**LIGO** PROJECTCALIFORNIA INSTITUTE OF TECHNOLOGY  
PASADENA, CALIFORNIA 91125

## FACSIMILE COVER SHEET

A couple of HMS plots from your tests of the first 60' QT tube section. We do not agree that acceptable leakage has been demonstrated on this section for the following reasons:

— ZIC FIRST DAY, TUBE BAGGED  
 - - - ZIC SECOND DAY, END SPRAYED

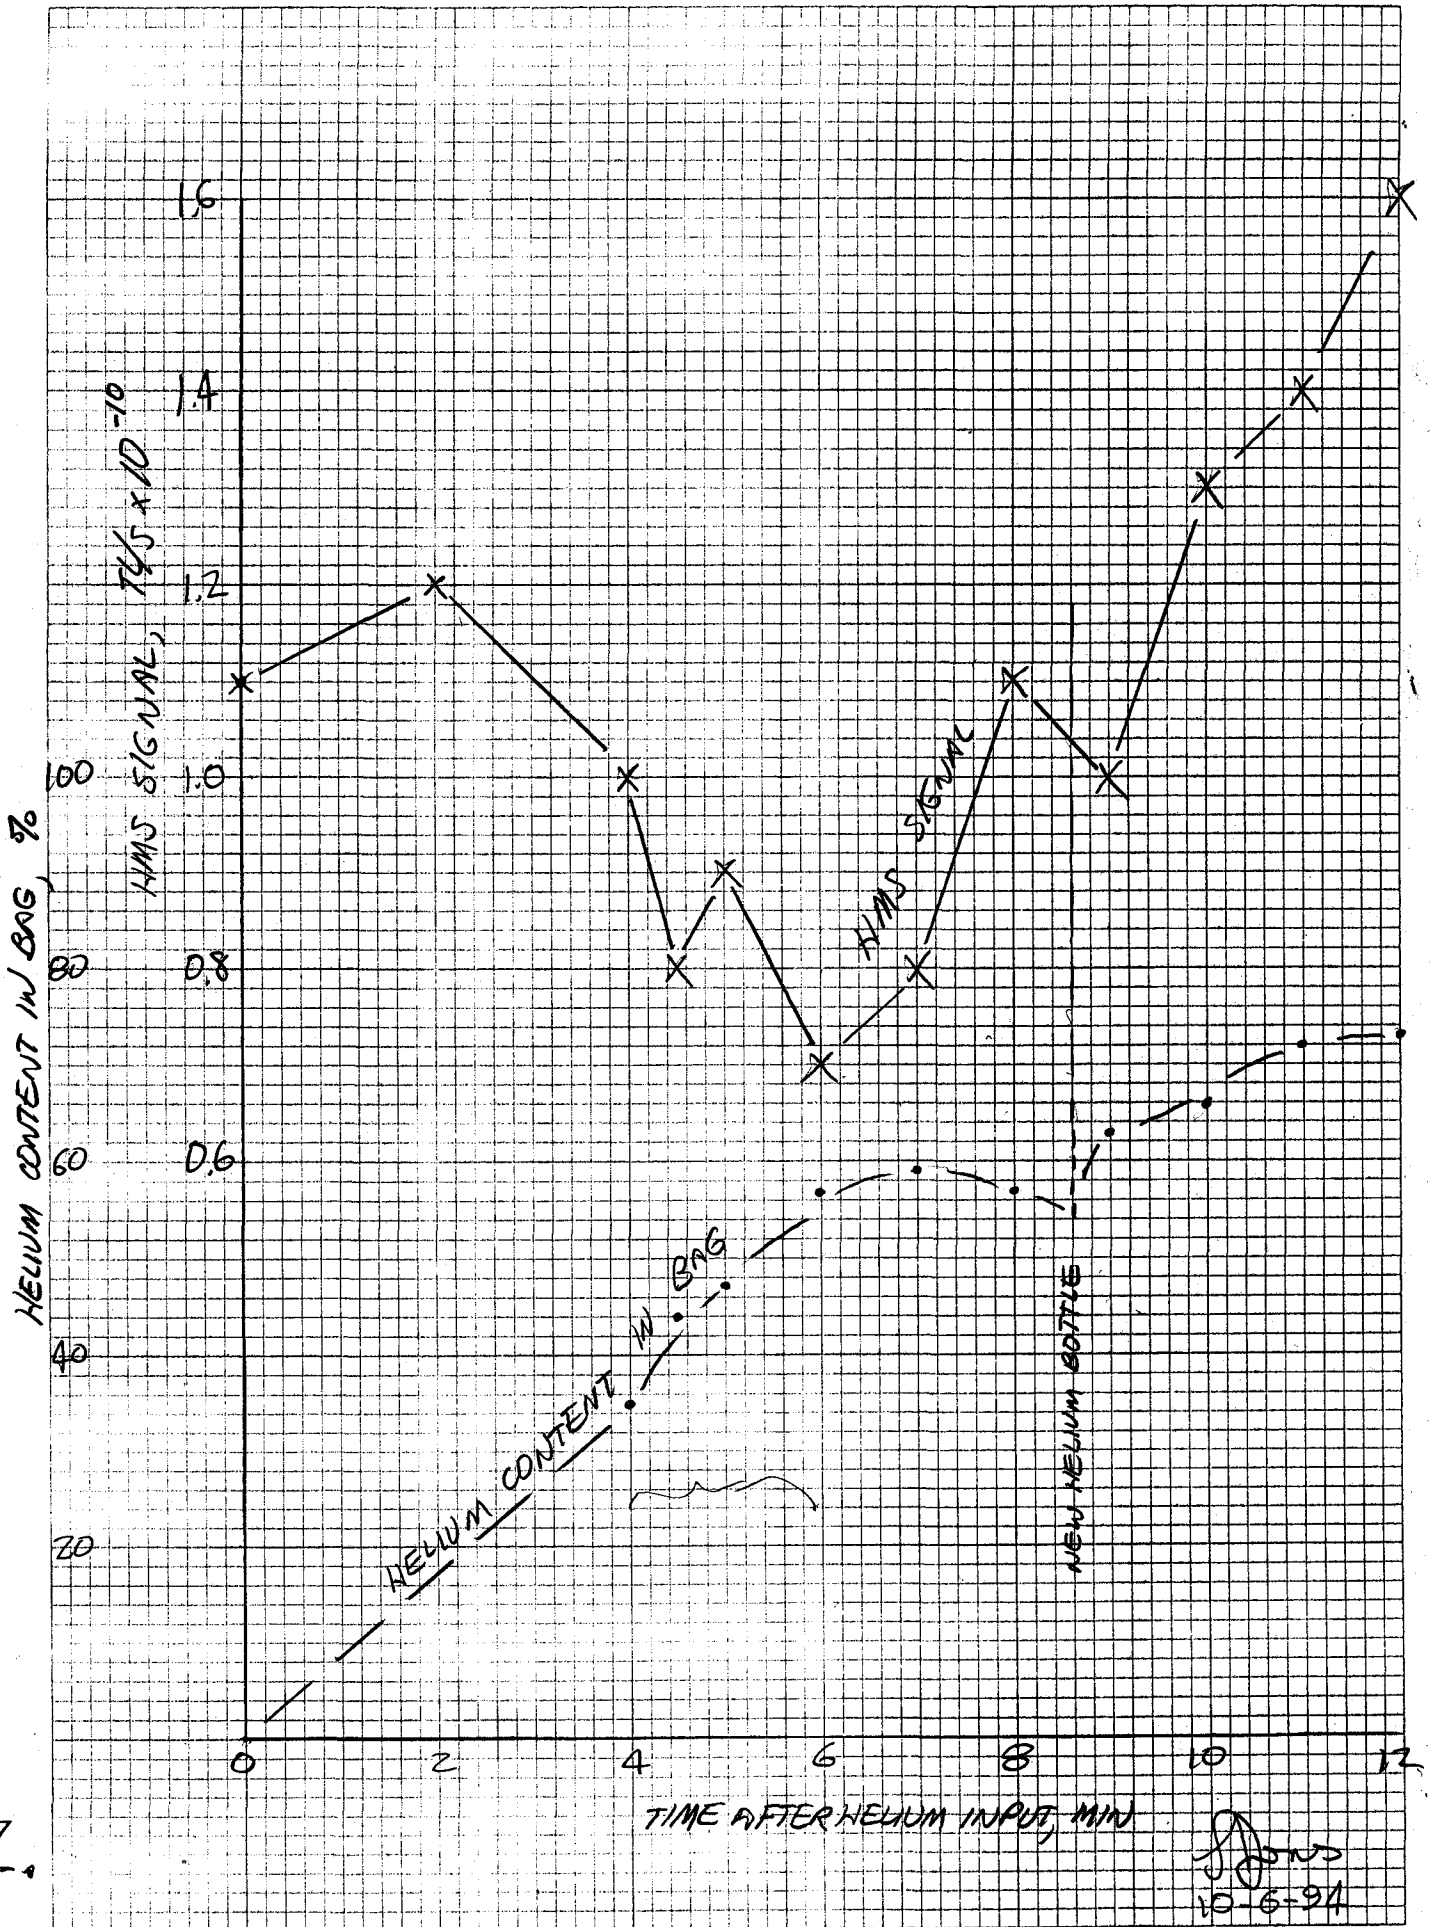
1. Bagged vs. sprayed: notice the size of the allowable  $1E-10$  tl/s leak versus the variation between tests: there is no way of detecting the absence (or presence) of this magnitude of leak between these two curves. Besides, there was no control of helium in the atmosphere surrounding the end cap seal in either test.
2. Bagged test: HMS signal rise occurred at approximately the time that the bag was 57% filled with helium (at the  $O_2$  sensor probe location), giving less than a minute hold time with 50% or more helium content.

We are not claiming that the tube section has an unacceptable leak, but that its acceptance has not yet been demonstrated.

As I mentioned by telephone yesterday, you may choose to demonstrate the acceptability of this tube section by performing a bag test of the complete QT tube module once it is assembled. The general concept of the slip-on end cap design must yet be demonstrated, either by the third tube section, or by subsequent testing.
